SCHWEIZER SERVICE BULLETIN

B-234
16 Dec 1991

SUBJECT: INSPECTION AND MODIFICATION OF LONGITUDINAL TRIM MOUNTING PLATE AND TRIM ARM STOP

MODEL AFFECTED: ● All Model 269B Helicopters
● Model 269C Helicopters with Serial Numbers 0001 thru 1415, 1417 thru 1439, 1441 and 1443

Figure B-234-1. Longitudinal trim mounting plate

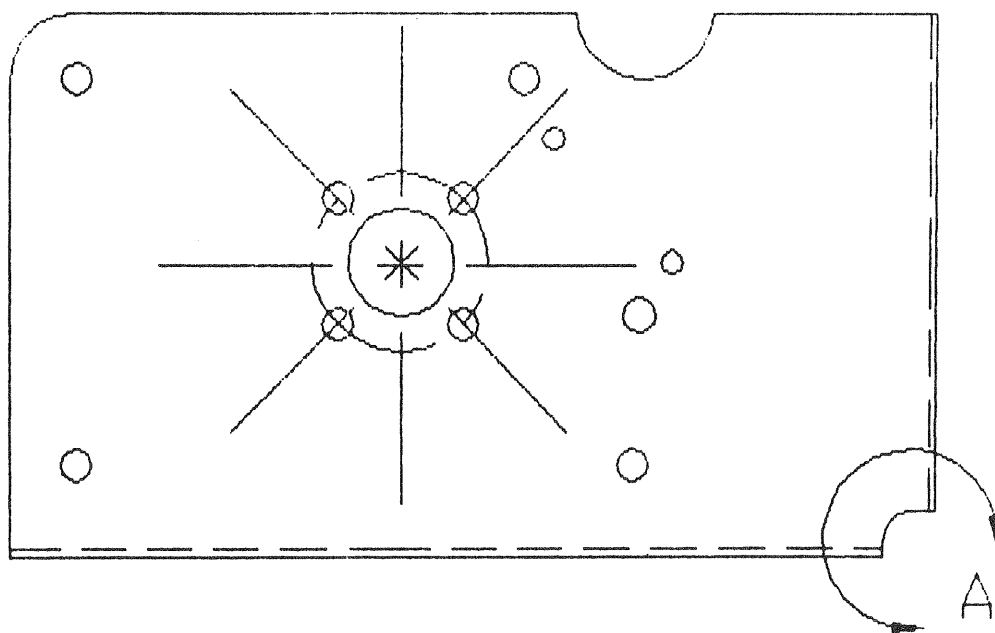
PREFACE: Field reports indicate the possibility of the longitudinal trim spring cover lodging between the cyclic longitudinal trim mounting plate and the cyclic stick.

- a. Remove pilot seat assembly to gain access to longitudinal trim assembly.
- b. Carefully remove carpeting (as required).
- c. Remove longitudinal trim assembly in accordance with BHMI, Section 8 (BHMI8).
- d. Disassemble longitudinal trim assembly as required (BHMI8).
- e. Locate section of longitudinal trim mounting plate to be modified (Figure B-234-1, Detail A-1).
- f. Using extreme care, remove excess material from longitudinal trim mounting plate, with grinder and/or file (Figure B-234-1, Detail A-2).
- g. Remove all burrs and sharp edges, and apply zinc chromate primer to reworked area.

Figure B-234-2. Arm stop

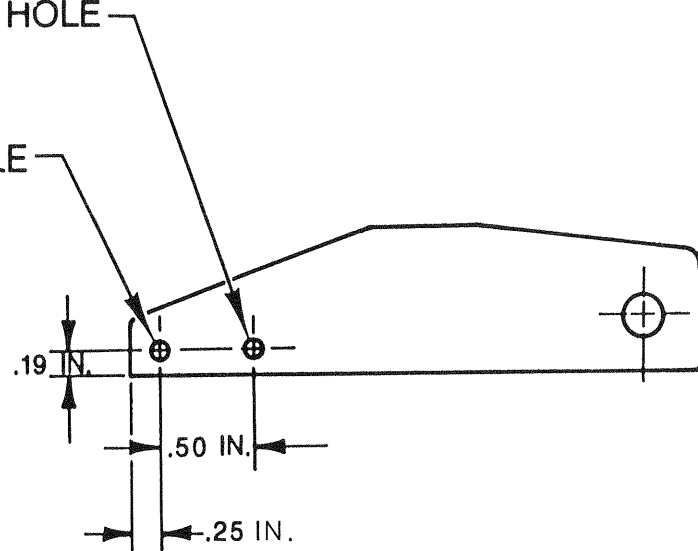
- (3) Disassemble longitudinal trim assembly as required (BHMI8).
 - (4) Mark arm stop from center of existing attachment hole in accordance with Figure B-234-2 and drill .13 inch diameter hole.

1. Outboard attachment hole, (using the aircraft centerline as the point of reference) shall be used for 269C helicopter.
2. Either attachment hole may be used for the 269B helicopter.
